Addendum 1

Bid No. 24-060-2024-PWI-002

New Tennis & Pickleball Courts at Mike Ford Tennis Center

Public Works Project No. 2024-PWI 002

TENNIS CENTER - NEW PICKLEBALL COURT		
City of Fairhope, Recreation Department		
Date: April 10, 2019	Drawn By: R.D. Johnson, PE	Addendum One
Scale: N.T.S.	2019-PWI 013

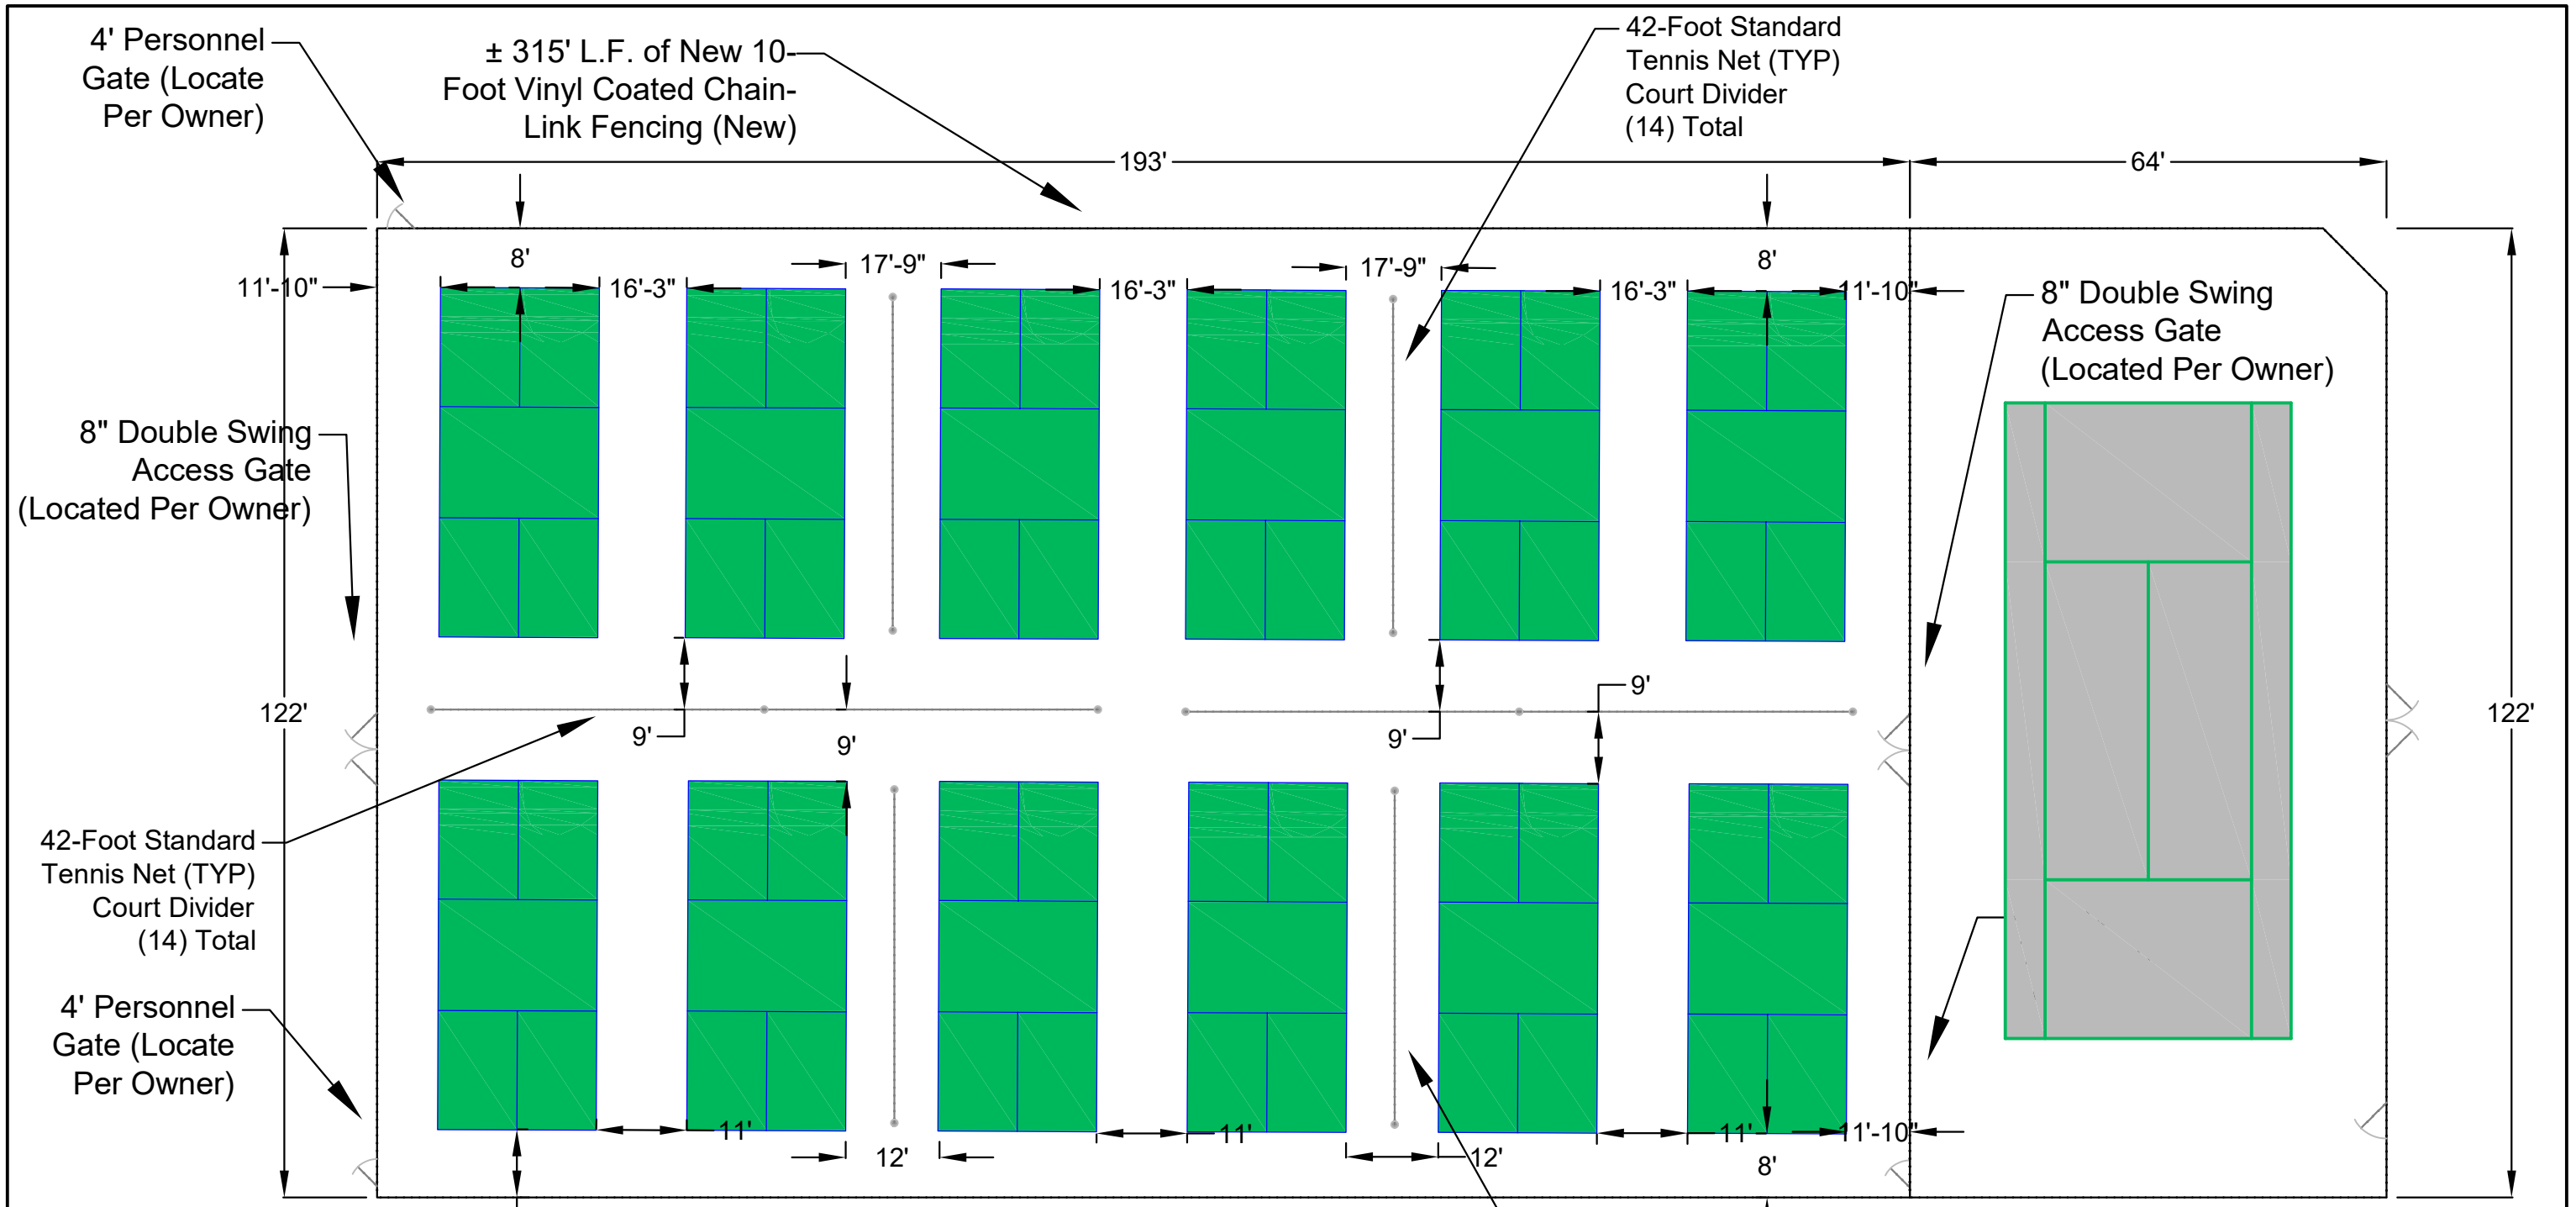
2. On Page 2 of the drawings, it states New Pickleball Courts 12 Total with 6' Fence. Is this supposed to be 6' or 10' fencing?
 - A. All fencing is 10'. See response No. 4 under Questions Submitted During the Pre-Bid Meeting and attached drawing.

4. Clarification on fence height?
 - A. All fencing shall be 10'-0" in height. This includes replacing the existing ± 250 Linear Feet of 6-Foot fencing (including gates) around Pickleball Court to be converted to tennis with 10-foot fencing.

5. Can you provide layout clarification for the northern courts, particularly pickleball, the layout dimensions don't sum to the overall dimensions.
 - A. See attached updated layout. Note: Overall dimensions of courts have increased to provide better geometrics and court spacing. The contractor awarded the bid will work with the City's Tennis Professional on the final court layout prior to applying court surfacing and lines. Some field adjustments may be contemplated.
